Lot 1, Town Centre REZ, PDP and SUP

File #PL2021-380 and #PL2021-411

December 2, 2021

Elevations – Storage Facility

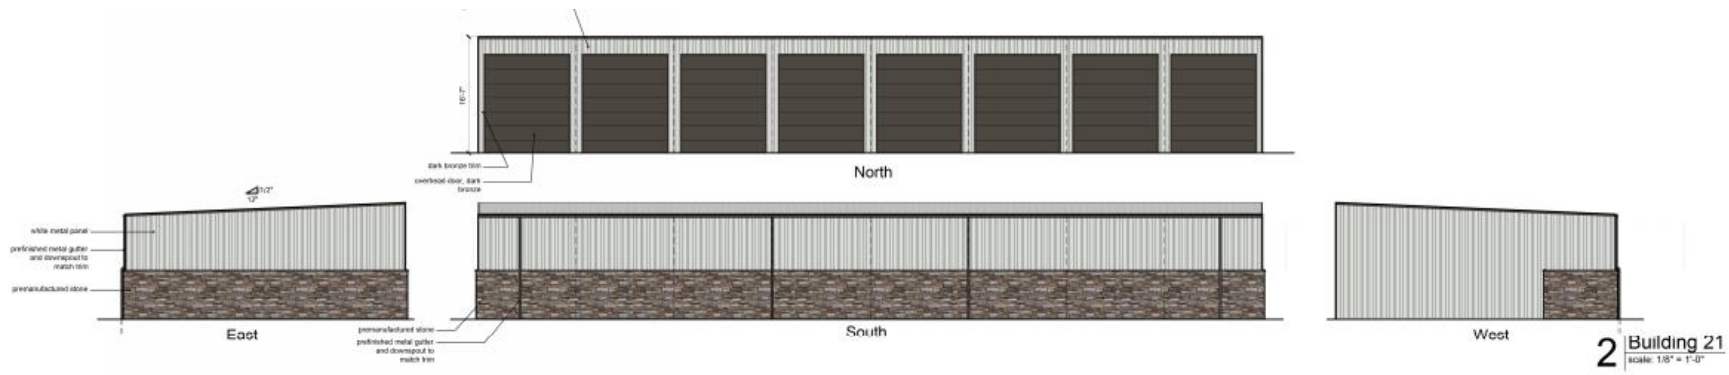
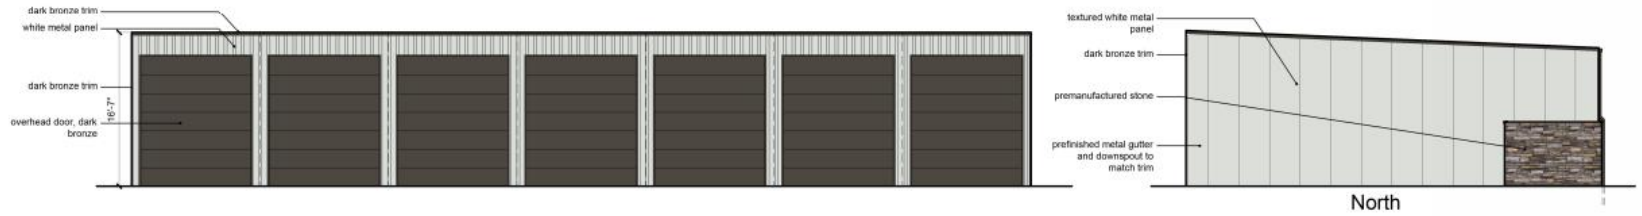
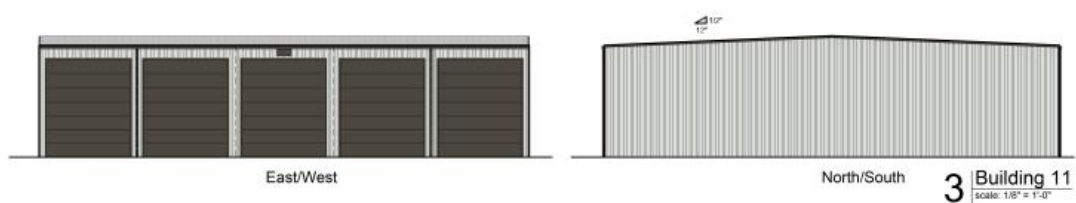
3. To comply with the requirements of the UDO, horizontal breaks, vertical breaks and architectural details shall be extended to all four sides of the proposed buildings in accordance with UDO Section 8.180.A and UDO Section 8.180.B.

Storage facility building roof pitch. Modification requested.

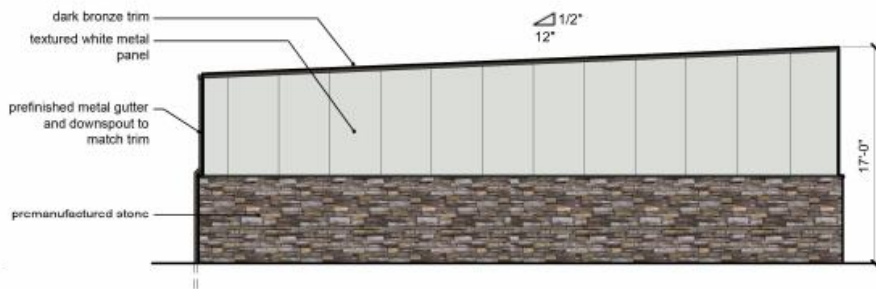
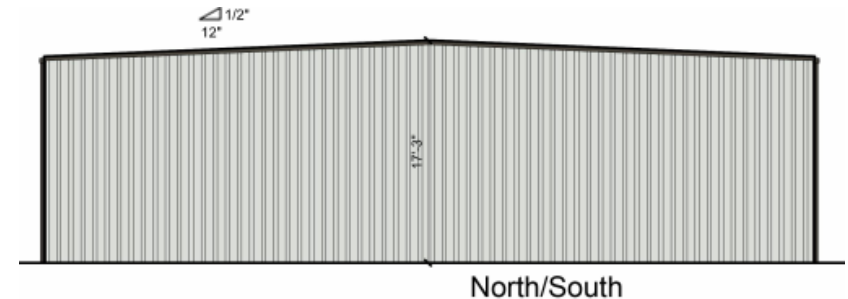
- Required – 1':3'
- Proposed – 0.5":1' (equal to 1.5":3')
- Recommended – The proposed storage facility buildings have a flatter roof pitch than required under the UDO. The proposed roof pitch is typical for industrial buildings and is common to industrial areas throughout the City. Given the area in which the buildings are located, staff supports the proposed 0.5":1' roof pitch.

1. A modification shall be granted to the 1':3' roof pitch requirement for the storage buildings, to allow a 0.5":1' (equal to 1.5":3') roof pitch.
2. To comply with the requirements of the UDO, corrugated metal panel systems shall not be used as an exterior building material on any building. Exterior building materials shall comply with the approved materials listed under UDO Section 8.170.A and 8.170.B.
